Access Compliance Report

Public Rights-of-Way

Intersection ID: 10027809	Main Street: HAGERSTONE_WY	Cross Street: N/A	Location: NE
ADA ID: 81C0D5683DEE	Ramp Type: Combination1	Initial Pass/Fail: Fail	Overall Compliance: No
			Severity Score: 33.75

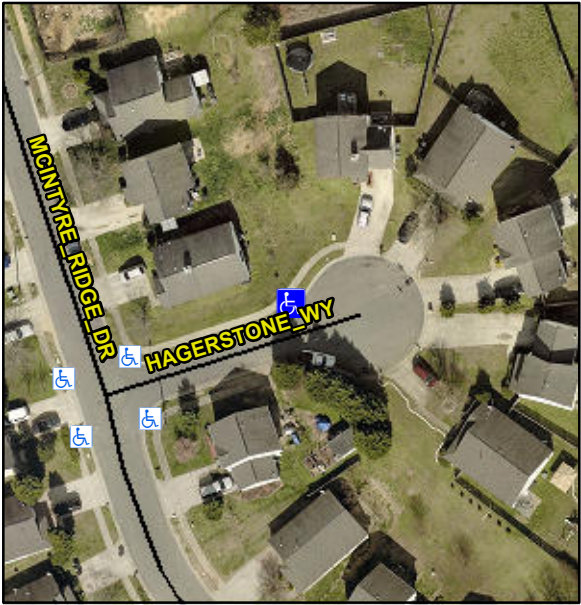
Codes/Mitigation Info/Possible Solution			Field Measurements/Component Compliance		
	Possible Solutions:		Compliance	Description	Data
	Remove & Replace Entire Ramp.		N/A	Ramp Length LT (in)	45.0
			Yes	Ramp Width LT (in)	49.0
			No	Ramp Slope LT (%)	9.6
			Yes	Ramp XSlope LT (%)	1.7
			N/A	Ramp Length (in)	44.5
			No	Ramp Width (in)	45.5
	Surveyor Notes:		N/A	Flare Type LT	N/A
	N/A		N/A	Flare Slope LT (%)	N/A
			N/A	Flare Traversable LT?	N/A
	PROW/ADA:		N/A	Landing Length (in)	N/A
	R304.5.1, R304.5.3, R304.3.2		N/A	Landing Width (in)	N/A
			N/A	Landing Slope (%)	N/A
			N/A	Landing X Slope (%)	N/A
			N/A	Landing Curb? (Y/N)	N/A
			N/A	Shared Landing?	N/A
			N/A	Gutter Ponding?	N/A
			N/A	Gutter Lip Ht (in)	N/A
			N/A	Painted X Walk1?	No
				X Walk 1 Direction	To S
				X Walk 1 Width (in)	N/A
				X Walk 1 Slope (%)	6.1
				X Walk 1 X Slope (%)	5.3
	Total Cost:	\$ 1800.00	N/A	Ramp inside XWalk1?	N/A
				Road Slope (%)	5.3

Road X Slope (%)	6.1
			N/A	Clear Space?	N/A
			N/A	Clear Space to XWalk (in)	N/A
			N/A	Any Obstruction?	N/A
				Obstruction Type	N/A
				Storm Grate/Utility Hazard?	N/A
				Storm Grate/Utility Type	N/A
					N/A
			Yes	Surface Condition? (G/P)	Good
				Curb Slope (%)	N/A
